STATE OF NORTH CAROLINA  
DEPARTMENT OF TRANSPORTATION

Subject: **Request for Modification and Extension to the Section 404 Individual Permit and Section 401 Water Quality Certification** for the proposed Greensboro Eastern Loop from US 70 Relocation to SR 2303 (Lawndale Drive), Guilford County, Division 7. Debit \$570 from WBS Element No. 34821.1.5, TIP Nos. U-2525B and U-2525C.

The NCDOT is requesting approval for additional impacts at U-2525C, Permit Site 20. The fill slope at this site extends further from the roadway than originally anticipated. Therefore, the reinforced concrete pipe (RCP) carrying this stream will need to be approximately 22 linear feet (lf) longer than previously permitted to accommodate the slope. Bank stabilization at the outlet is reduced from 30 lf to 15 lf due to right of way constraints. Impact number changes resulting from this modification are presented in this application in **red**.

Sheet 57A of 70  
(showing revisions at Site 20)  
Added 4/8/19

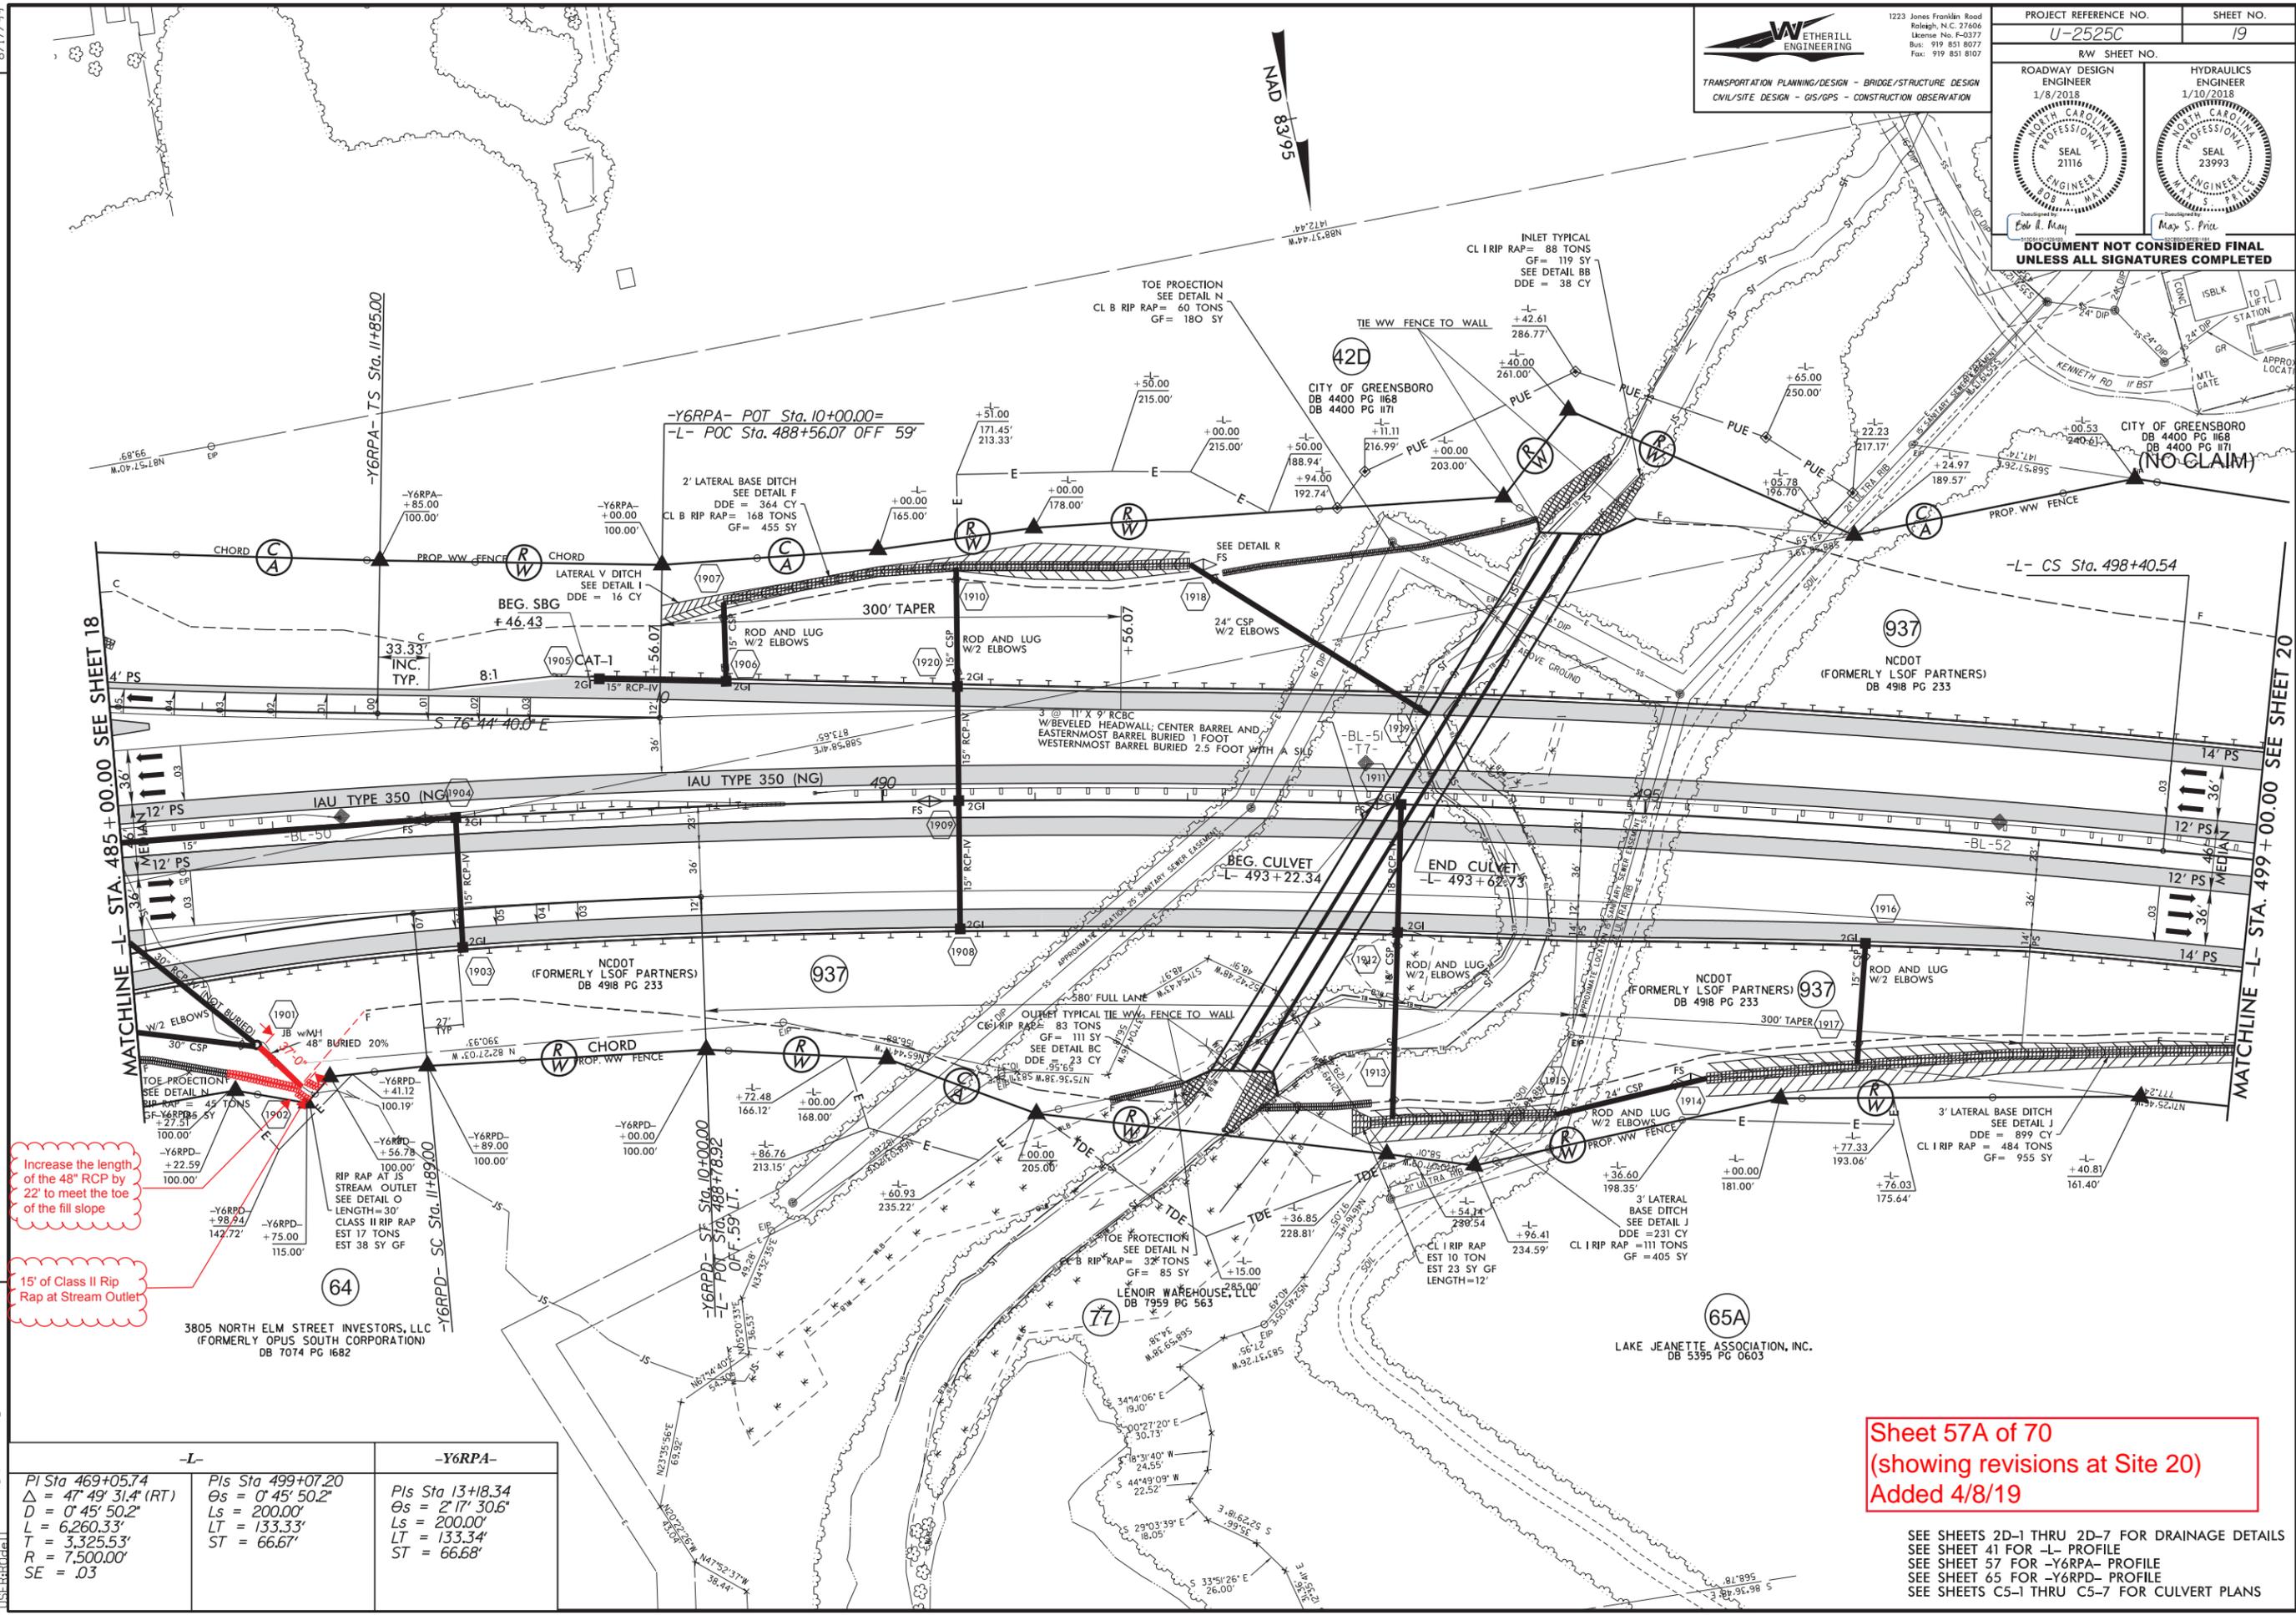
Increase the length of the 48" RCP by 22' to meet the toe of the fill slope  
15' of Class II Rip Rap at Stream Outlet

**Permit Site 20 (Revised):** The proposed roadway will result in **616 lf** of permanent stream impacts, <0.01 ac (18 lf) of temporary stream impacts, and **15 lf** of steam bank stabilization to stream SBG. Flow from this stream will be carried in a 30” RCP and extended with a 48” RCP at the outlet (not buried).
